Product / Process Change Notification (PCN)

PCN #: PCN_UtUOST_20220408

Affected Series: WE-UOST

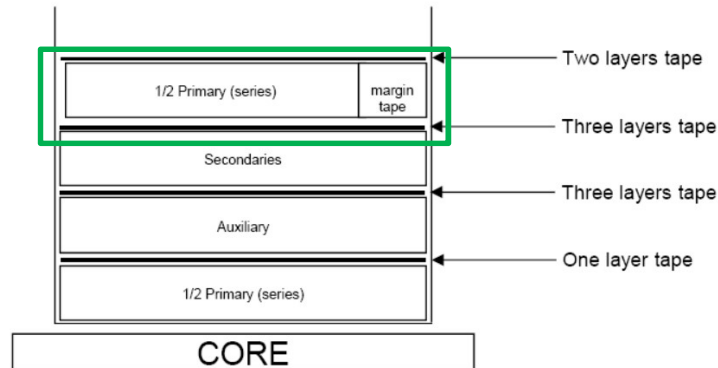
The addition of margin tape will be added to the last winding on the pin 1-6 side of the product. The margin tape will be either WF-2901 or PF-301-2L from JINGJIANG YAHUA PRESSURE SENSITIVE GLUE CO.,LTD (E165111). Please see the table below showing what parts will use WF-2901 or PF-301-2L. Please see below and on the next page the general winding build and photo of the tape addition. Attached to the email is the UL construction files and winding builds for each part number if needed.

Before the addition of margin tape.

After the addition of margin tape.
